Welch Allyn, Inc. 4341 State Street Road Skaneateles Falls, NY 13153 USA	URGENT: Field Safety Notice	2021-07-001-MKE-005
---	------------------------------------	---------------------

ELI280, MLBUR280 and BUR280 Electrocardiographs

ELI280 resting electrocardiograph - Patient mismatch/Software Upgrade

Figure.1

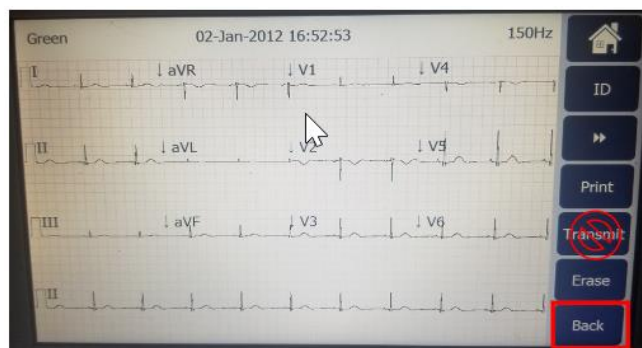
1. An ECG is acquired for Patient A and stored to the cardiograph.
2. An ECG is acquired for Patient B and stored to the cardiograph.
3. The ECG record associated with Patient A is retrieved from memory and any Patient Demographic information is edited.
4. After editing, the "Resting ECG" screen is presented as shown below. Figure 1
5. Pressing the TRANSMIT button from this screen (following any Patient Demographic edit) will transmit an ECG record other than for patient A. (see figure 2, which shows the Resting ECG screen).

If an ECG record is retrieved from the patient directory for a Patient Demographic edit to be performed, once the information has been edited and the screen above (Fig 1) is presented, do not press the transmit button. Instead, press the BACK button which will SAVE the changes to memory and present the user with the following screen, where the SYNC button can be used to transmit the desired record to the configured destination.

Figure.3

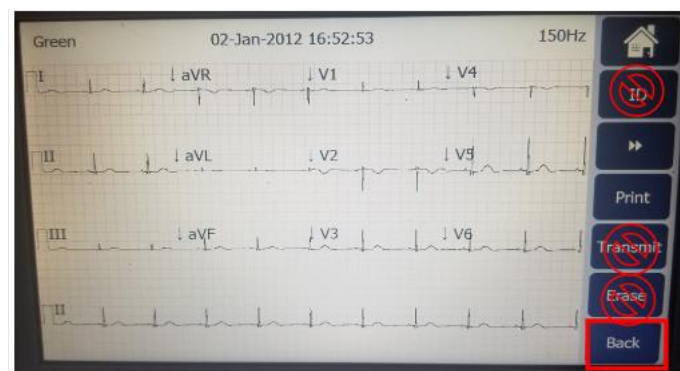
1. An ECG is acquired for Patient A and stored to the cardiograph.
2. An ECG is acquired for Patient B and stored to the cardiograph.
3. The ECG record associated with Patient A is retrieved from memory and ID information is edited.
4. After editing, the “Resting ECG” screen is presented as shown in Figure 3.
5. The user decides to make another ID Edit without leaving the “Resting ECG” screen and presses the “ID” button - Figure 3.

6. After the second edit is performed, the “Resting ECG” screen is once again presented as shown above.
7. Pressing the TRANSMIT button from this screen (following two ID edits in a row as defined above) will transmit an ECG record with the patient demographics

from Patient A and the ECG record for Patient B, this “hybrid” record is then stored in the cardiograph as second record with patient A demographics, and Patient B will no longer be listed in the directory.

Figure.4

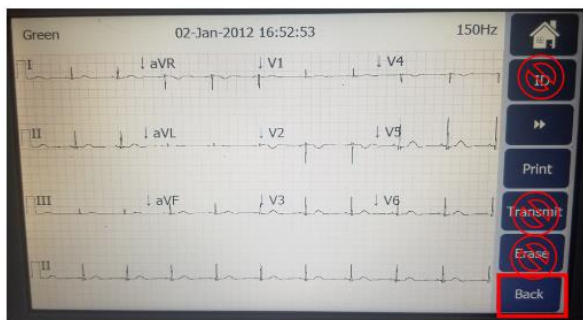
If an ECG record is retrieved from the patient directory for an ID Edit to be performed, once the information has been edited and the screen (Figure 4) is presented, do not press the Transmit, Erase, or the ID button. Instead, press the BACK button which will SAVE the changes to memory and present the user with the DIRECTORY screen (Figure 5). Subsequent ID Edits should also be performed using this workflow to prevent this issue from occurring. To then transmit the record to the configured location, press the SYNC button.
